Service Information

SI0399

YVAA 170mm Steel Discharge Line Design Change

YVAA 170MM STEEL DISCHARGE LINE:

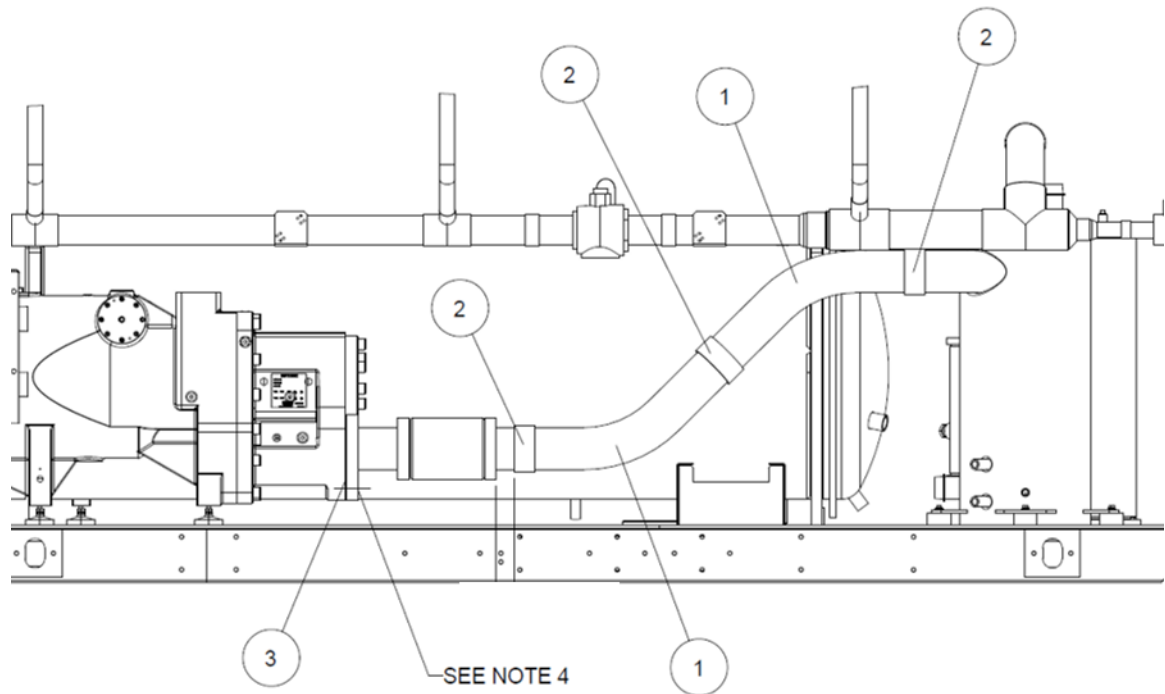
Through job site applications it has been discovered that specific YVAA chiller circuits with the 170mm screw compressor may exhibit discharge line cracks due to excessive vibration. The design has been updated in May 2016 with the use of steel instead of copper for the discharge line material. This design change is only applicable to the units and circuits with the 170mm screw compressor.

Items 1 and 2 are designed to fit without modification. However, DO NOT weld before fitting on chiller.

ASSEMBLY PROCEDURE: DISCHARGE LINE

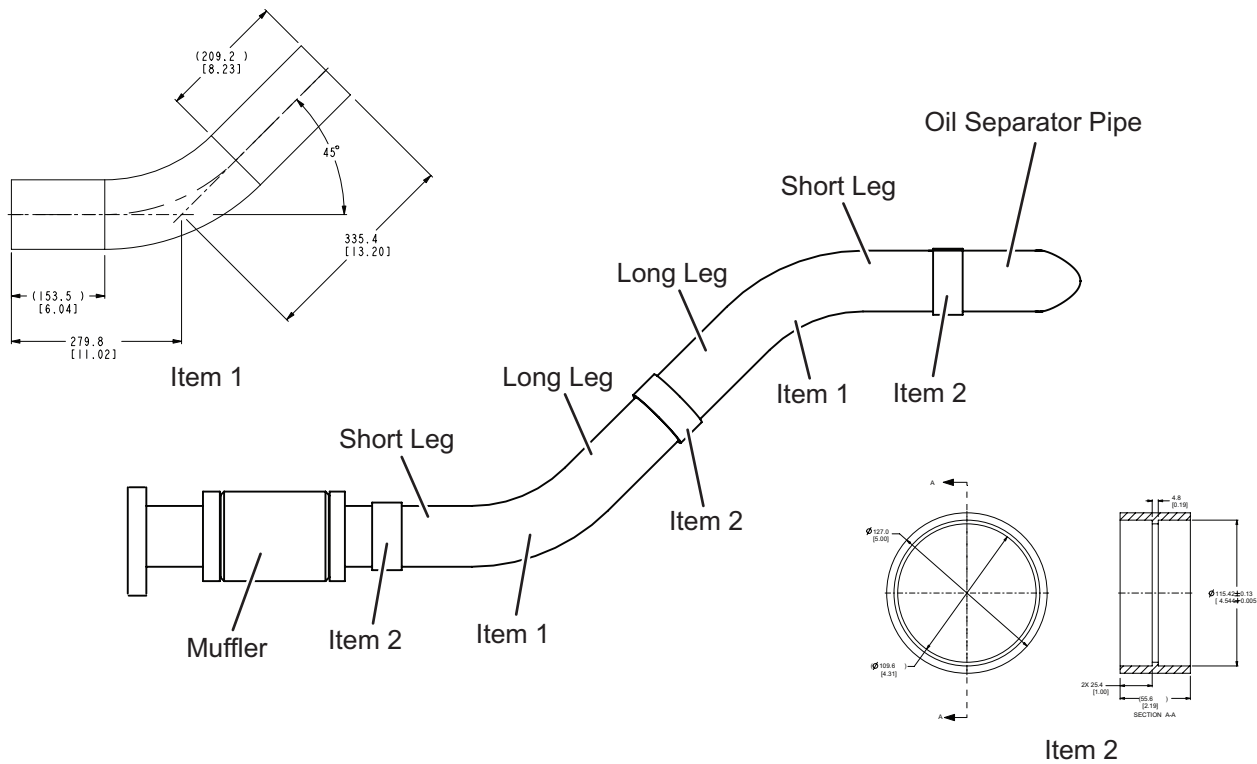
1. Loosely Fit Items; 1, 2 And Muffler Together.
2. Insert Item 2 Over Oil Separator Pipe
3. Insert Muffler And Piping Assembly Into Item 2 Of Oil Separator Pipe.

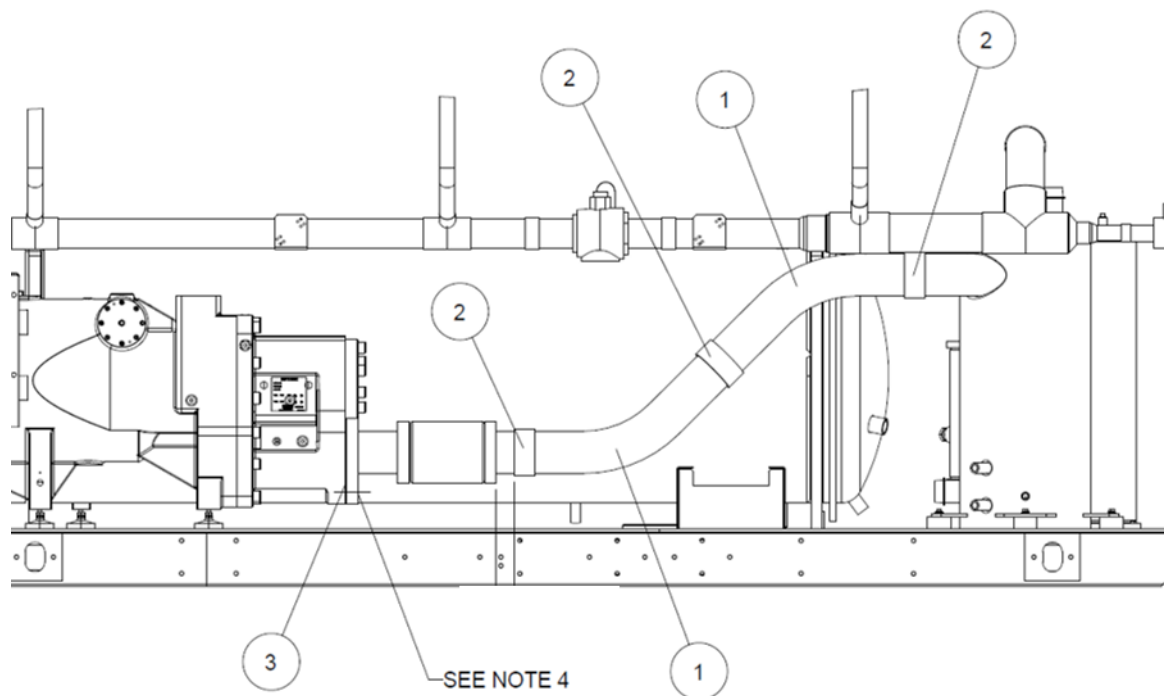
4. Torque Muffler Bolts To 160 Ft-Lb (217 N-M).
5. Weld Assembly: Minimum 2 Layers Of Weld.
6. Use Old Muffler Gasket While Brazing Then Replace With New Muffler Gasket After Brazing.

ASSEMBLY PROCEDURE: BALL VALVES

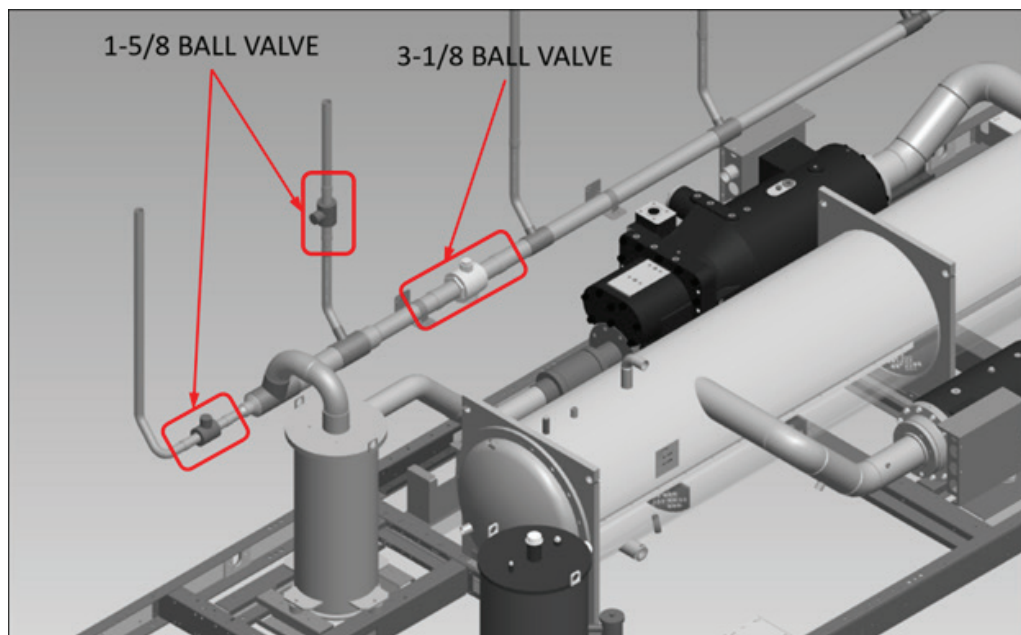
1. Cut Piping Where Indicated Below.
2. Be Sure To Remove All Chips From Piping.
3. Braze Valves In The Locations Indicated.
